APPLICATION NO.	FILING DATE	FIRST NAMED INVENTOR	ATTORNEY DOCKET NO.	CONFIRMATION NO.
10/798,476	03/10/2004	Joshua David Banko	4860.P3250	7410

Office Action Summary	Application No. 10/798,476	Applicant(s) BANKO, JOSHUA DAVID	
	Examiner Matthew G. Kayrish	Art Unit 2627

DETAILED ACTION

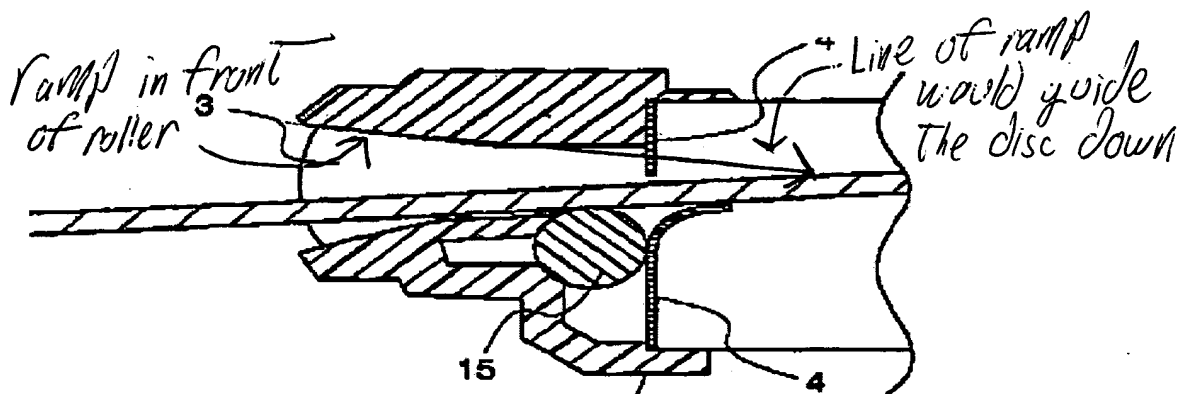
disk guide is coupled to the functional bezel via the connection means, which can be seen in figure 2 below:

Therefore, the examiner maintains that Sugita does teach a disk guide coupled to the functional bezel.

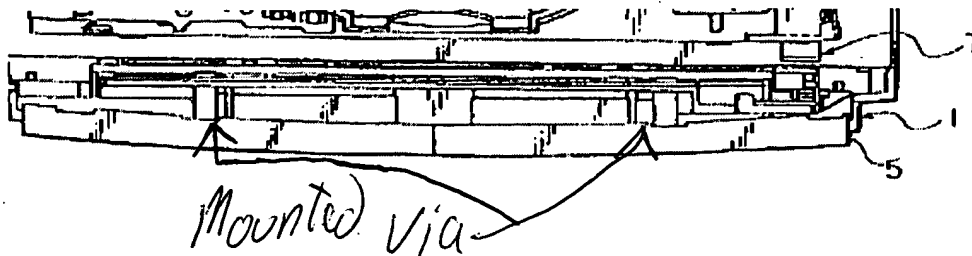
Regarding the argument that Kan-o does not teach a ramp feature, which points the disk down during injection and up during ejection. The examiner maintains that Kan-o does teach a ramp portion in front of the roller, and this ramp can be seen clearly in figure 13 below:

It can be clearly seen that from figure 13, the line extended from the ramp does indeed indicate the direction of the disc during injection and ejection. When the disk is in abutment with the ramp, it can clearly be seen that the disk will either be pointing down during insertion, and up during ejection. Furthermore, Kan-o states that the roller will direct the disk to the slot, which is encompassed by ramp feature of item 24, otherwise,

the disk will stuck within the disk drive. Therefore, the examiner maintains that Kan-o does teach a ramp feature to point the disk down during insertion and up during ejection.
